Access Compliance Report Public Rights-of-Way (Curb Ramps)

Main Street: CECIL_PASTURE_RD Cross Street: CECIL_PASTURE_RD Location: W

ADA ID: RPRK211102124930 Ramp Type: Type 1 - Perpendicular Initial Pass/Fail: Pass Overall Compliance: No Severity Score: 5

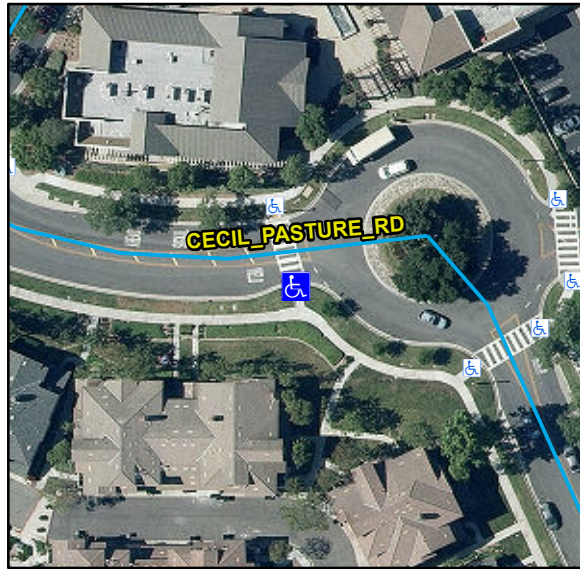
R304.5.4, R304.5.3, STD 1115

Yes	Ramp Inside Crosswalk 1	Yes	Yes	Ramp Inside Crosswalk 2	N/A
	Crossing 1 Slope (%)	1.8		Crossing 2 Slope (%)	N/A
	Crossing 1 Cross Slope (%)	2.1		Crossing 2 Cross Slope (%)	N/A
Yes	Gutter Ponding	No	Yes	Curb Slope	1.2
Yes	Gutter Lip Height (in)	0		Road Run Slope (%)	N/A
No	Gutter Run Slope (%)	9.8		Road Cross Slope (%)	N/A
No	Gutter Cross Slope (%)	3.1			
Yes	Overall Surface Condition: Acceptable		Yes	Perp Joint Present	Yes
	Cross Gutter Present?	No		Spandrel Present?	No
	Replace Cross Gutter?	N/A		Replace Spandrel?	N/A

Remove & Replace Gutter.
